ARTESIA PUMP STATION ADDITIONAL WELL NOS. 7 AND 8

Solicitation No: CO-00416

ADDENDUM 5

Date: SEPTEMBER 22, 2021

Figure 2-4: Artesia PS Structural Cross Section

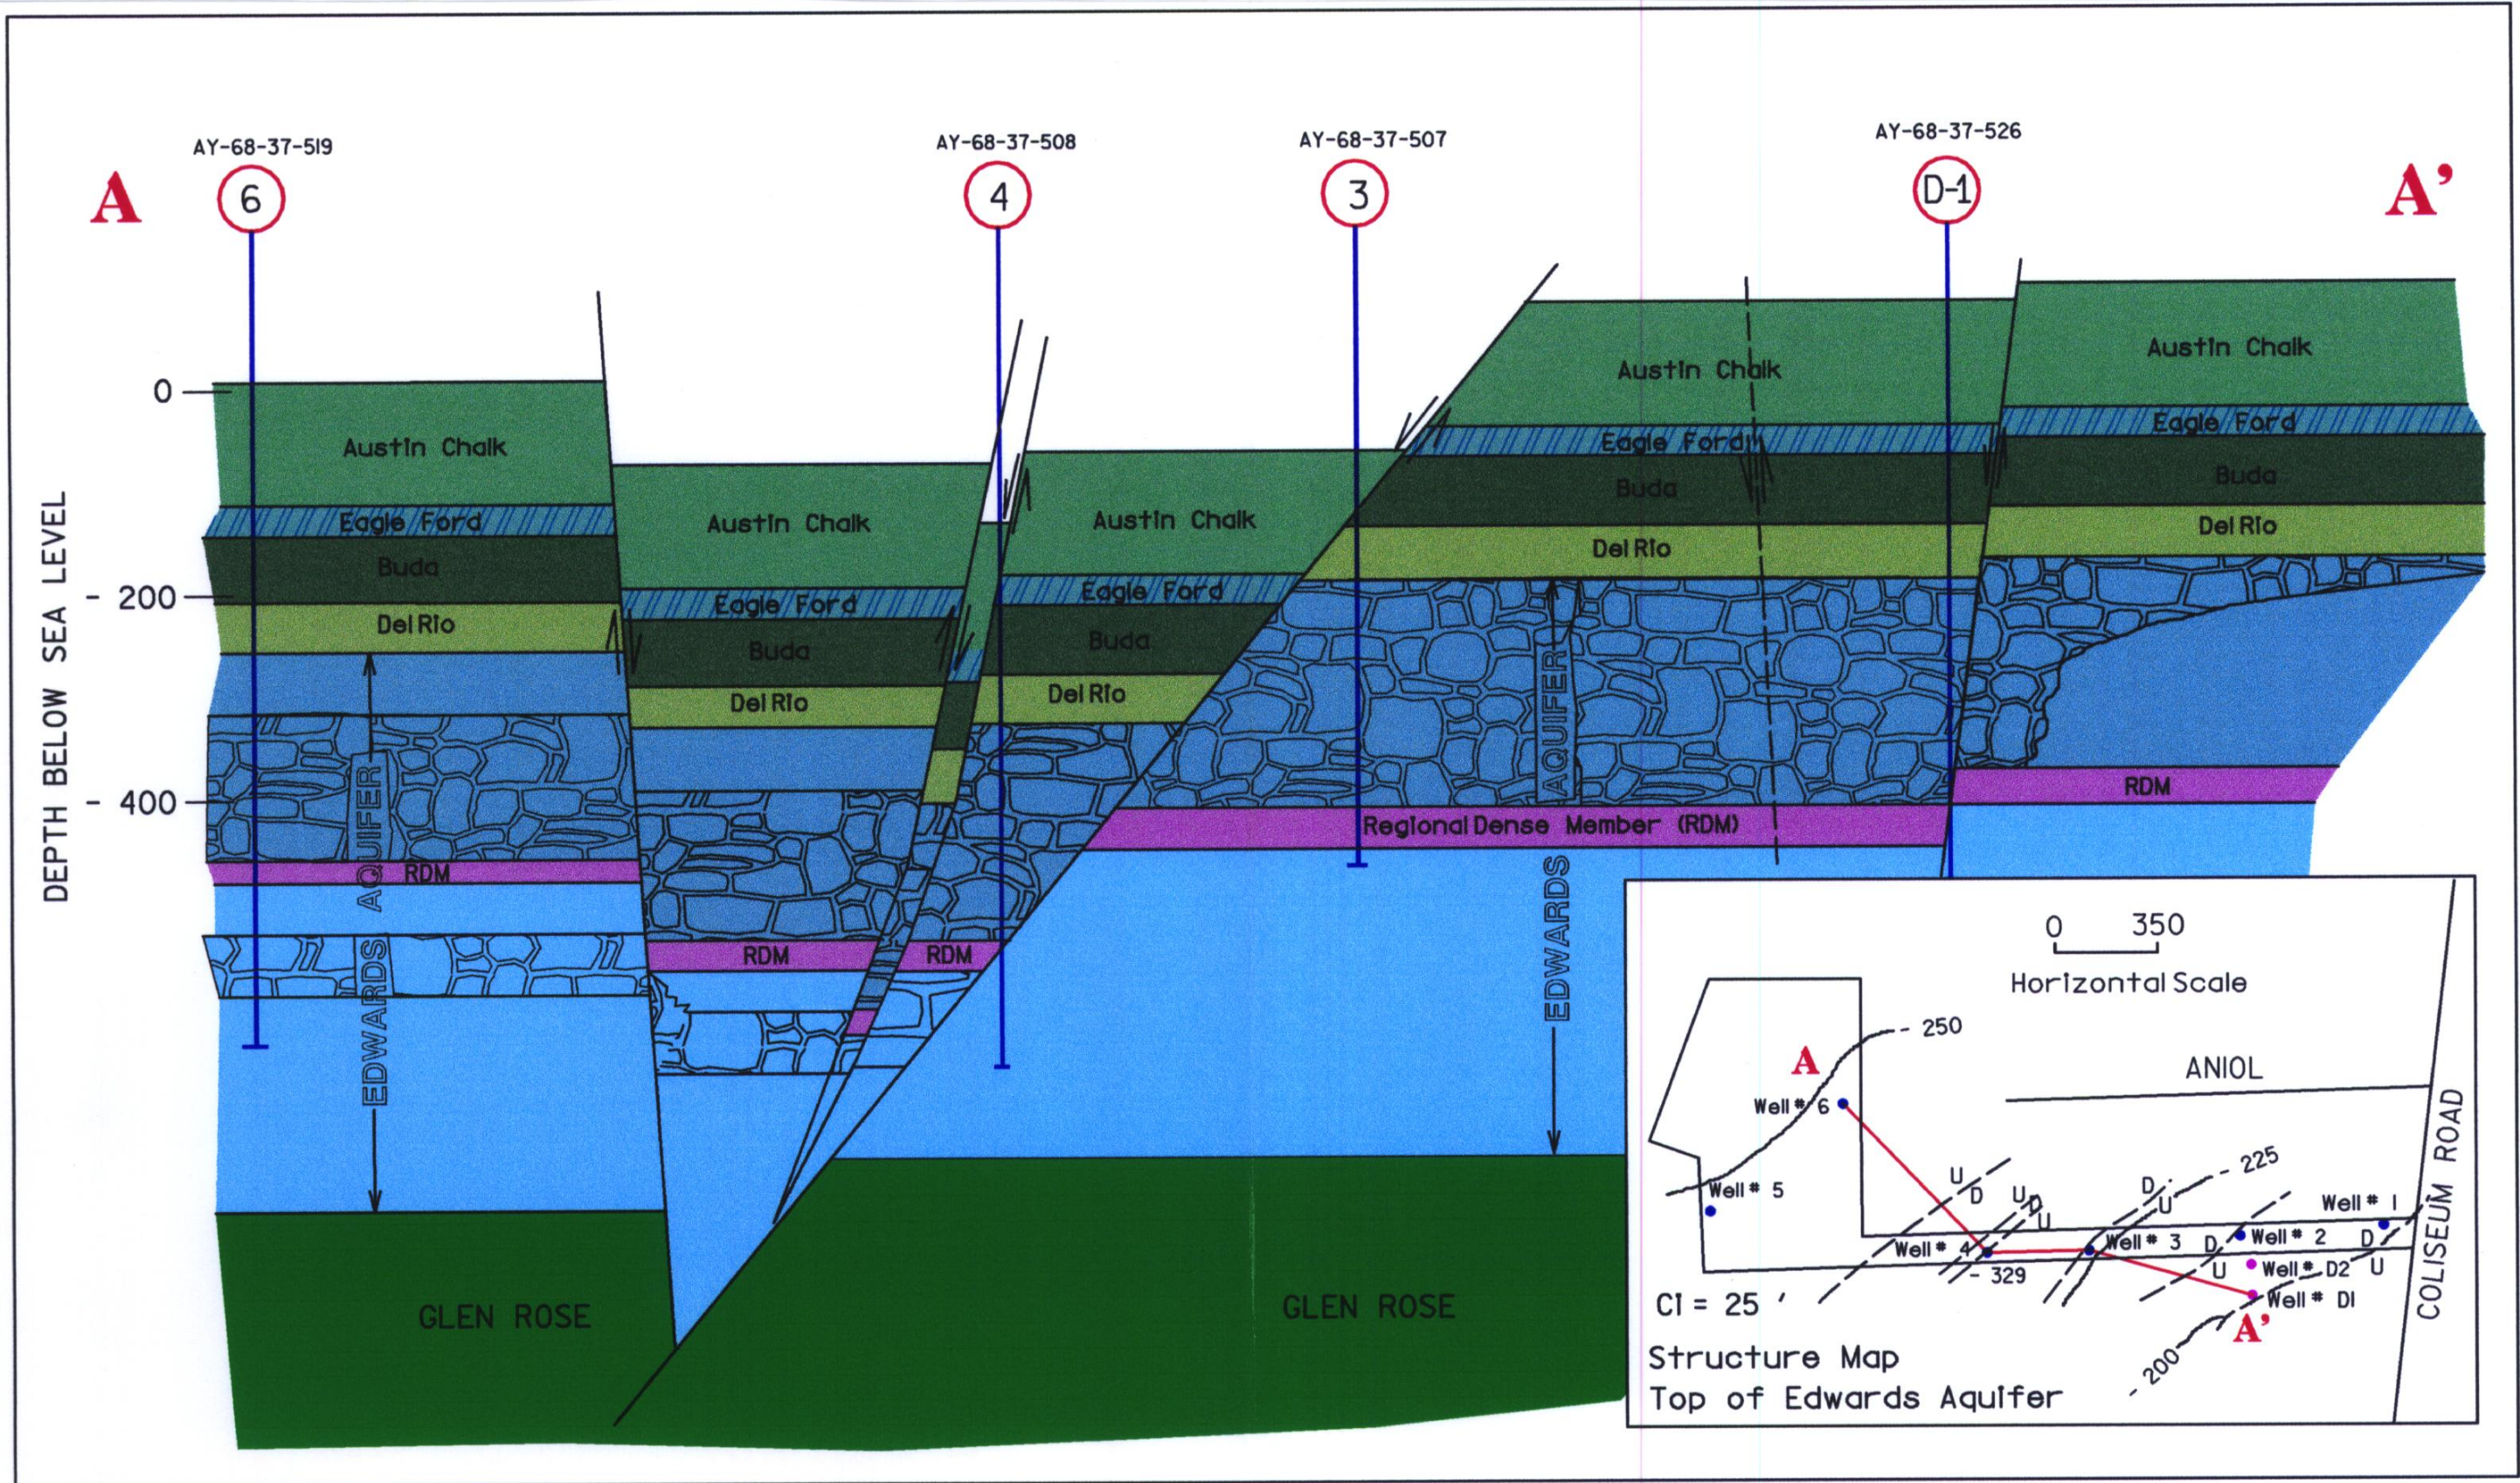
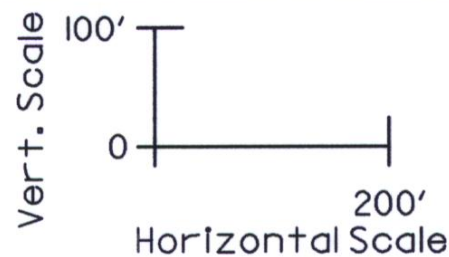
7. **Question:** After reviewing the driller’s logs provided by SAWS and found on TWBD, the lithology between the 4 previously drilled wells (2, 3, 4, and 5) varies significantly. For example, the top of the Austin Chalk is at 616’ on Well 2, 602’ on Well 3, 799’ on Well 4 and 664’ on Well 5. Do you have any information that would indicate there is a fault that runs through that area that would explain the significant differences in the depths of the formations encountered at each well site?

Response: Refer to attached Figure 2-4, “Artesia Pump Station Structural Cross Section Showing Possible Cavernous Zones.” This is the known structural geology of the site developed by Shultz and others, 1999. The expected formation contact depths should be similar to Well #6 (plugged) on the far left-hand side of the drawing.
